RECORD PLANS

PROPOSED IMPROVEMENT
 BRIDGE PROJECT

PROJECT NAME: MENDON
PROJECT NUMBER: BRO 1443(43)

STA 51+41 RT. (ABUT #1)
 BEGIN UNCLASSIFIED CHANNEL EXCAVATION
 BEGIN STONE FILL, TYPE IV
 BEGIN GEOTEXTILE UNDER STONE FILL
 BEGIN GRUBBING MATERIAL
 END GRUBBING MATERIAL 51+56 RT.

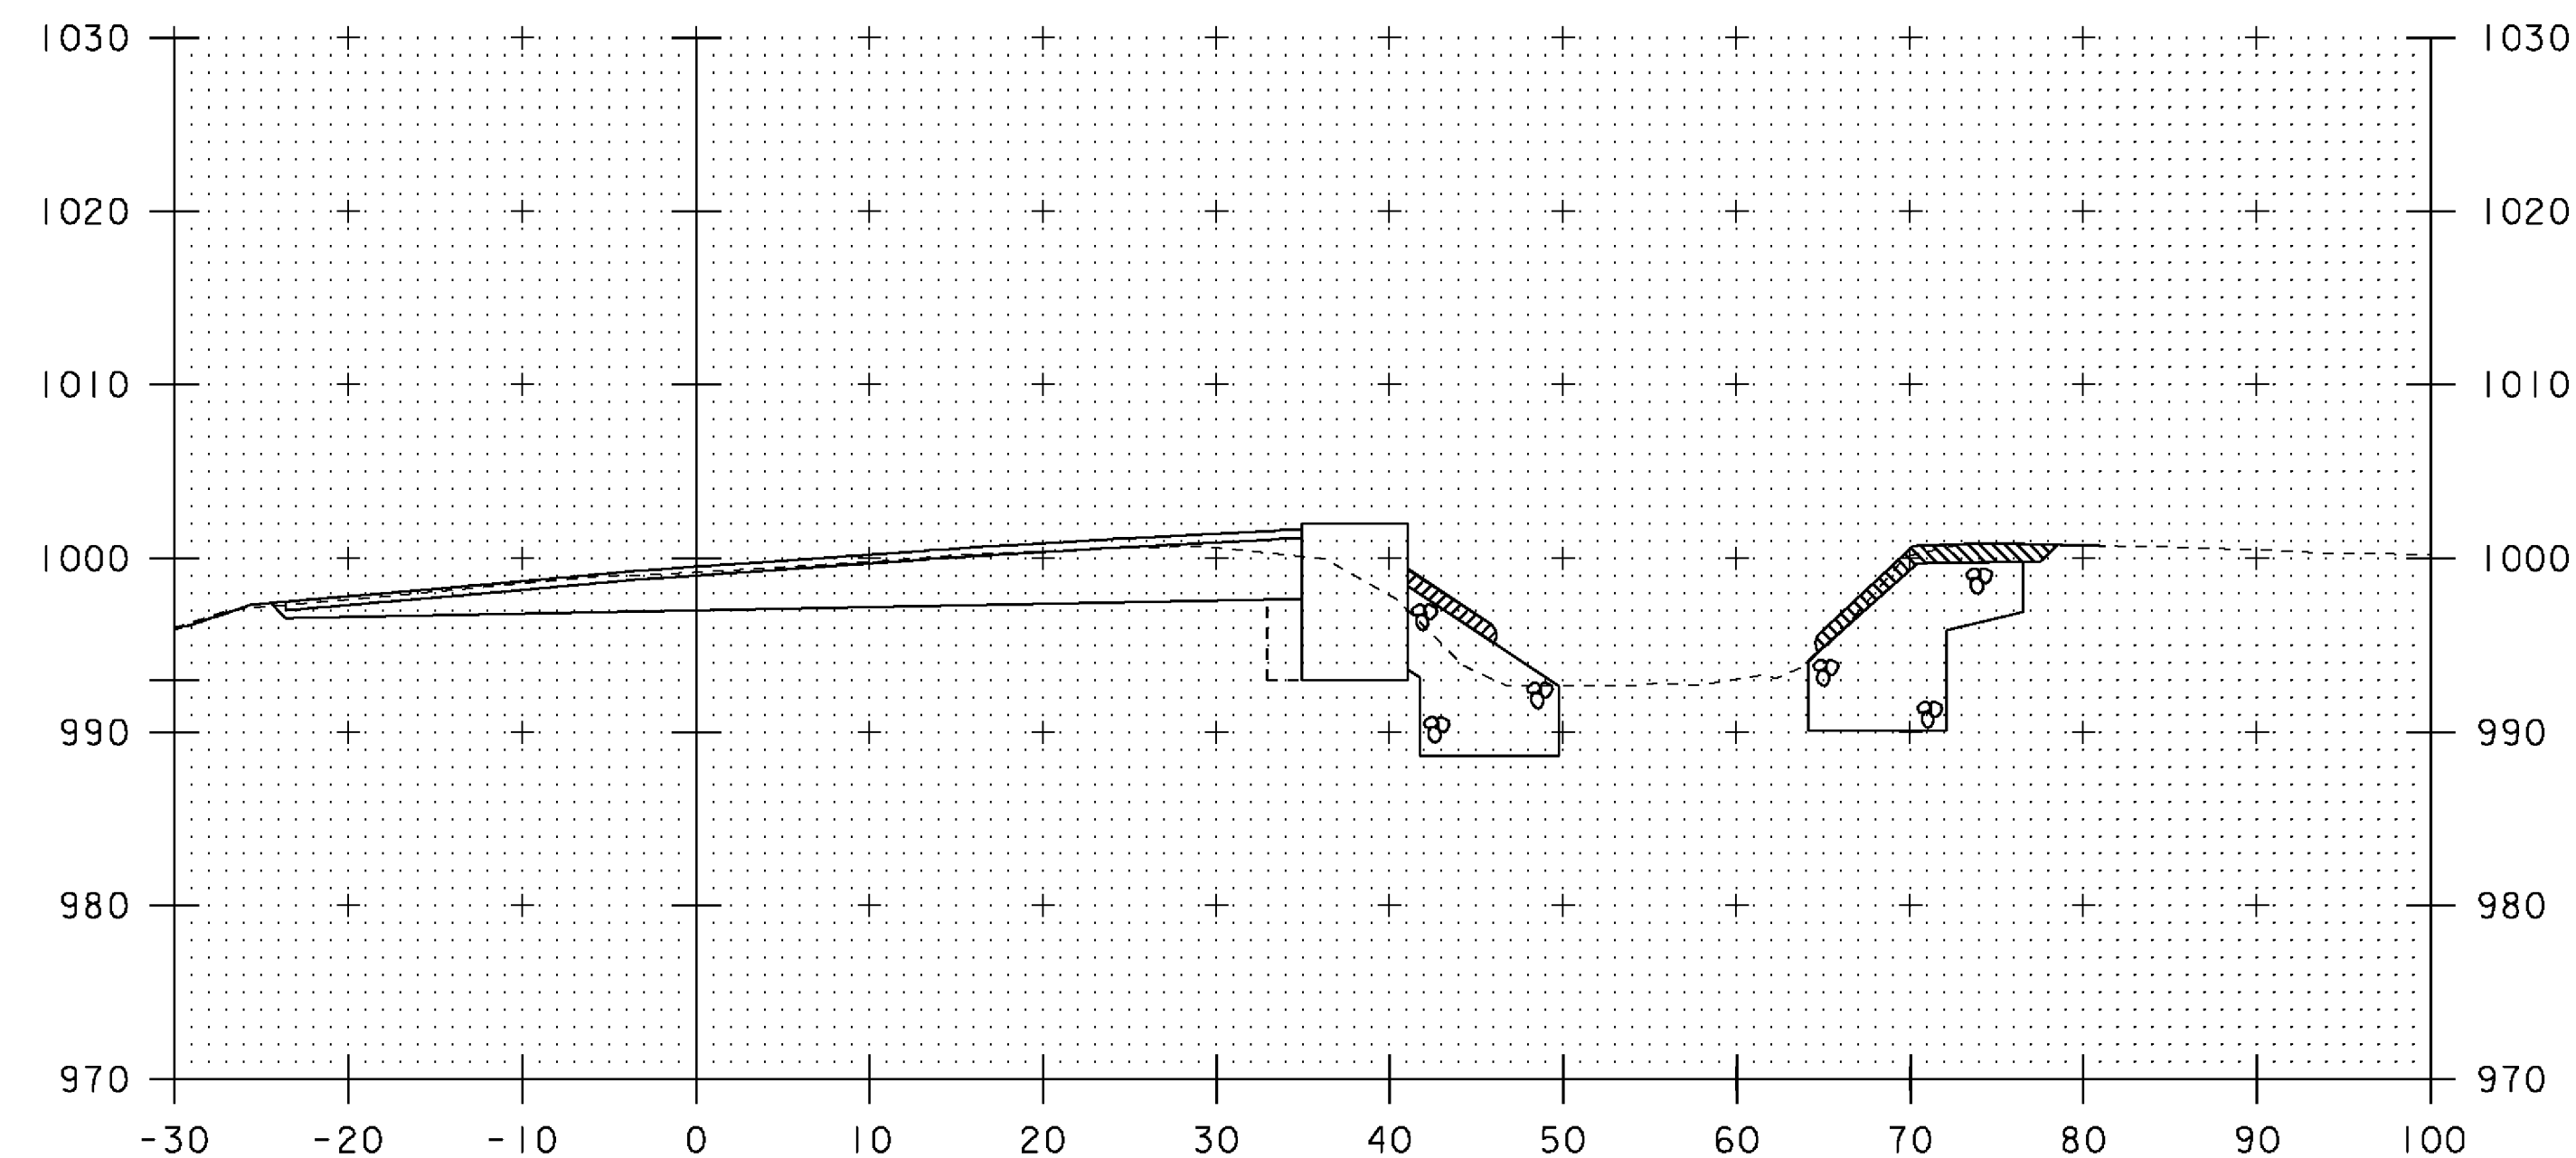
EXISTING GROUND NO LONGER VALID SINCE IRENE 8-28-11.
 NEW SURVEY REQUIRED FOR CHANNEL SECTIONS
 (TYP ALL SHEETS 31 & 32).
